**Addendum No. 1**  
**August 24, 2022**

Project name: Health Sciences Surgical Simulation Suite Renovation  
University of South Dakota  
Sanford School of Medicine  
OSE #R0622—05X  
Architecture Incorporated Project #:0217.2984.22

Scope of this Addendum:

**HEALTH SCIENCES SURGICAL SIMULATION SUITE RENOVATION**

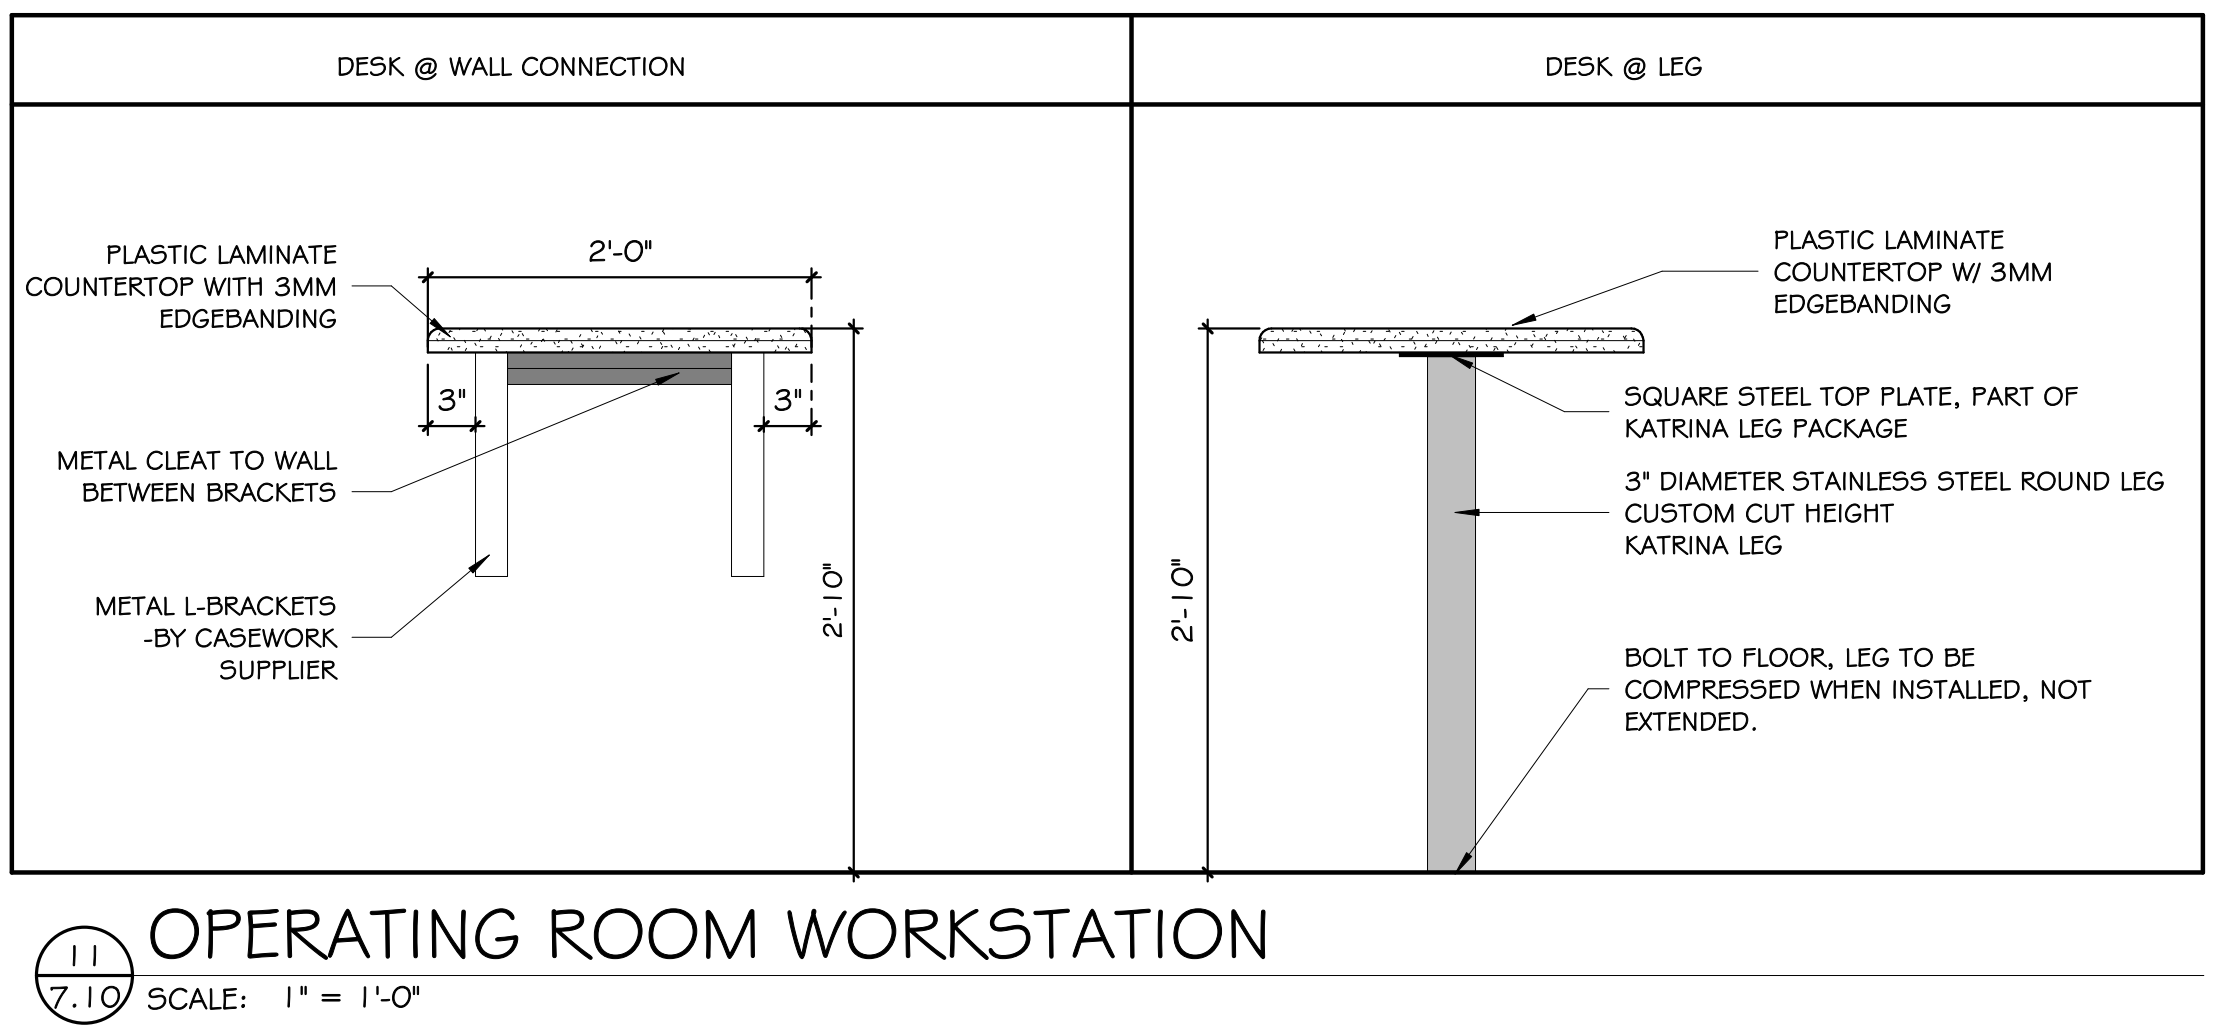
4) DRAWING 7.10 – CASEWORK SECTIONS

- a) Detail 3/1.10 – Tall Storage – High Shelf
  - i) Omit note for Kaba punch lock. Kaba punch locks were eliminated from the project.
